Recycled Water Reuse Program
Idaho Department of Environmental Quality
Twin Falls Regional Office

City of Bellevue

Municipal Permit M-112-03

2025 Inspection Report

Photo 4: Headworks Bandscreen Monster grit screening system

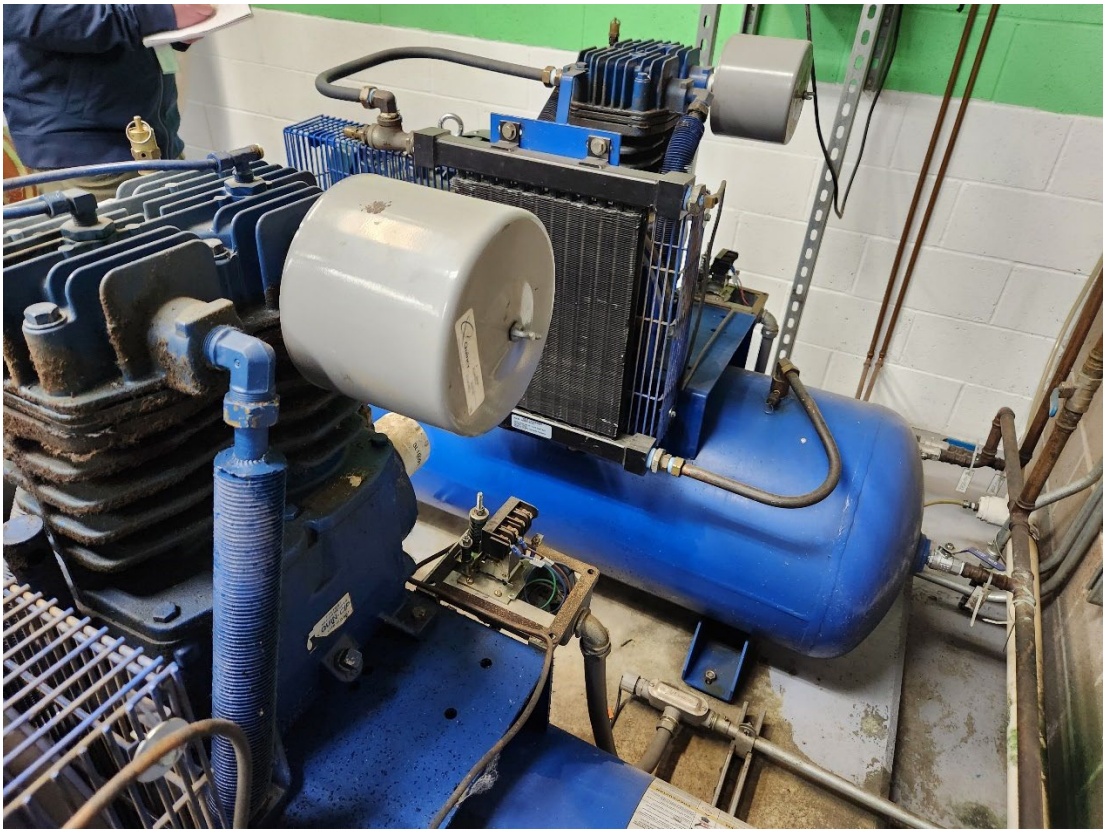
Comments: The WWTF is under active construction with considerable piping and electrical work to be completed following a process failure that flooded the facilities lower gallery in 2023. Gas monitoring equipment was fixed to the wall above the bioreactor trains but was not in service at the time of inspection (Photograph 2). The bioreactor trains for the MBR plant were not in operation at the time of inspection. Mr. Ellsworth noted that the stagnant water in the bioreactor trains was from precipitation. There was some trash observed by DEQ staff at the bottom of the basins. The concrete integrity of the basins appeared to be in good condition. Bellevue staff identified hydrogen sulfide corrosion under the headworks floor grating (Photograph 3) and noted the limited ventilation of the room fanning air into a generator outside the room. Bellevue staff noted that their plan was to restore the concrete of the basin and reline it to prevent corrosion in the future. DEQ staff noted that there was less moss growth on the headworks Bandscreen Monster grit screening system than the previous inspection in 2023 and overall odors in and around the building were minimal (Photograph 4).

Please submit a work plan as part of a corrective action plan within 30 days to DEQ outlining the items needed to return the MBR plant to operation as designed.

Photo 6: New Endress Hauser (Promag W model) electromagnetic flow meter ready for replacement.

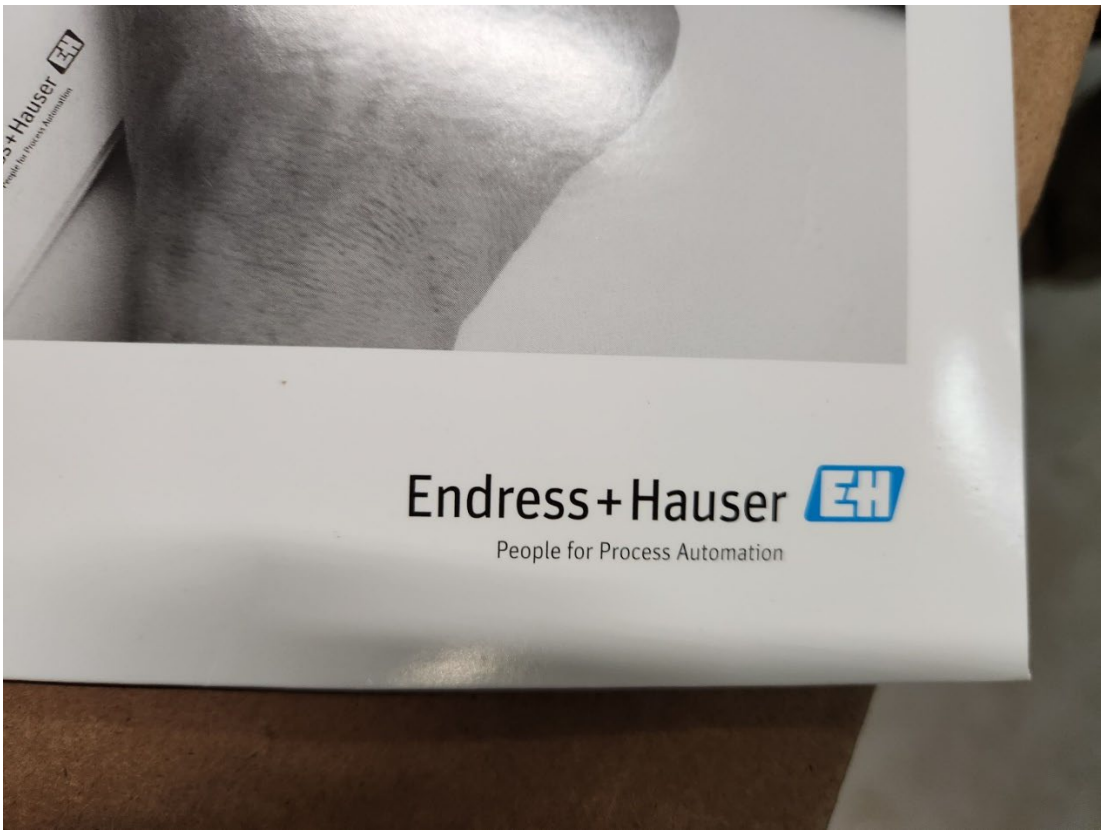
5.5	For flow metering, describe flow meters used, and what they measure.			
Comments: The facility uses Endress Hauser (Promag W model) electromagnetic flow meters to measure recycled water and SIW discharges to the management units (Photograph 6, 7 and 20).
